## REMARKS

### Objections to the drawings:

FIG. 2  
 (PRIOR ART)

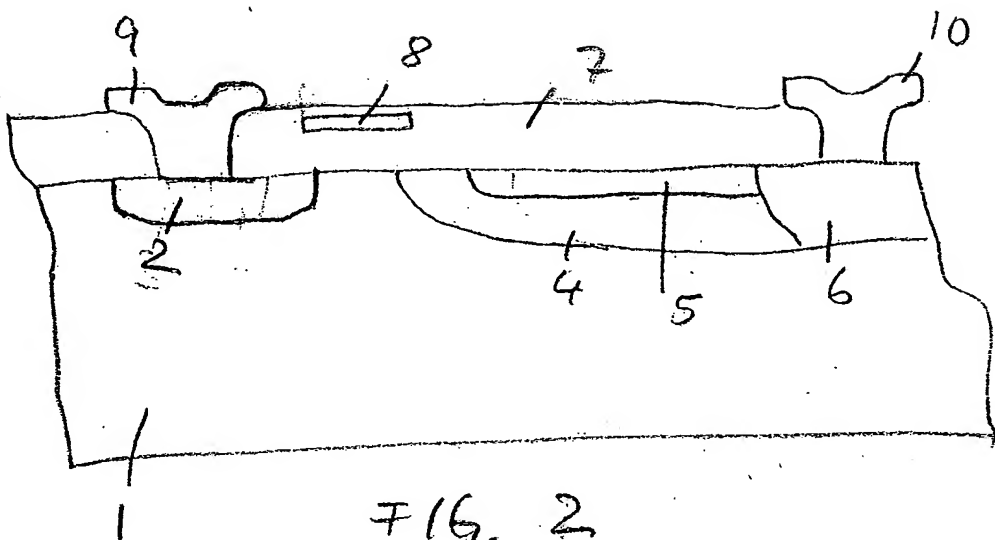
The specification has been amended to properly identify numeral 9 in Fig. 2. The source electrode is shown in Fig. 2 similarly as drain electrode 10. thus, no new matter has been added.
